QUALITY ASSURANCE -- NON-CONFORMANCE REPORT

Location: Changxing Island, Shanghai, P.R. China **Report No:** NCR-000326
Prime Contractor: American Bridge/Fluor Enterprises, a JV **Date:** 16-Jun-2009
Submitting Contractor: Zhenhua Port Machinery Company, Ltd (ZPMC), Changxing Island **NCR #:** ZPMC-0300

Reference Description: Missed UT Indications by QC, Welds SEG032D-007 and SEG033B-020, Segment 6CE

(UT探伤发现的缺陷总长度小于最大允许长度。) SEG032D-007

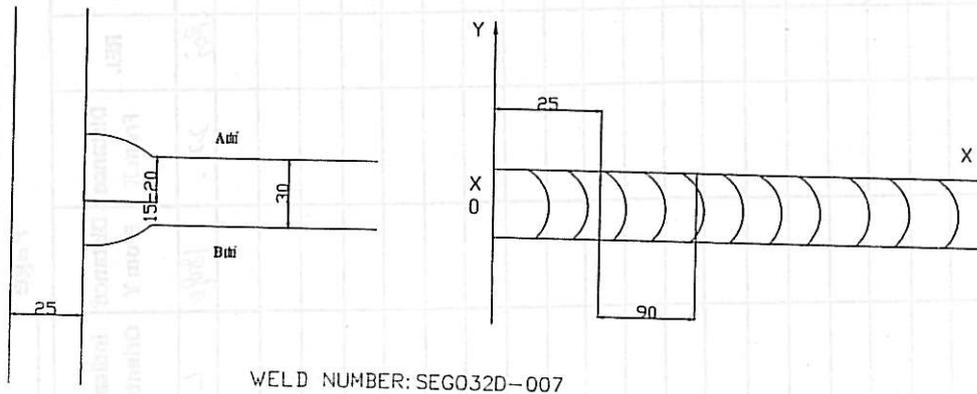
Rejected indication found by ultrasonic inspection is less than the maximum allowance aggregate length.

- 1. 从缺陷距离端面较近一侧 ($D \leq 1/2T$, D为缺陷深度, T为板厚) 采用碳刨或打磨的方法去除焊缝缺陷;
 - 2. 参照返修焊接工艺规程 (WPS) 准备正确的接头型式, 预热和焊接;
 - 3. 若返修需要进行多道修补时, 需将前道焊缝清理干净并与周围焊缝平滑过渡再进行后续操作;
 - 4. 焊前对修补区域进行VT检测保证缺陷完全被消除;
 - 5. 将修补区域打磨到与母材或邻近焊缝平齐;
 - 6. 根据批准的车间图纸检查焊缝.
- 1. Gouge or grind from nearer side from metal edge ($D \leq 1/2T$, "D" is depth of defects, "T" is thickness of metal) to remove all defects;
 - 2. Follow repair WPS for joint preparation, preheat, and weld deposit;
 - 3. It is necessary to grind the above repair root welding cleaning and flush with the adjacence weld before go to next working procedure if the repair area need to be repaired by multiple pass.
 - 4. Verify with VT no defects remain in the weld joint prior to welding;
 - 5. Grind the repaired area flush with base metal or the adjacent weld;
 - 6. Check the welds according to the working drawings.
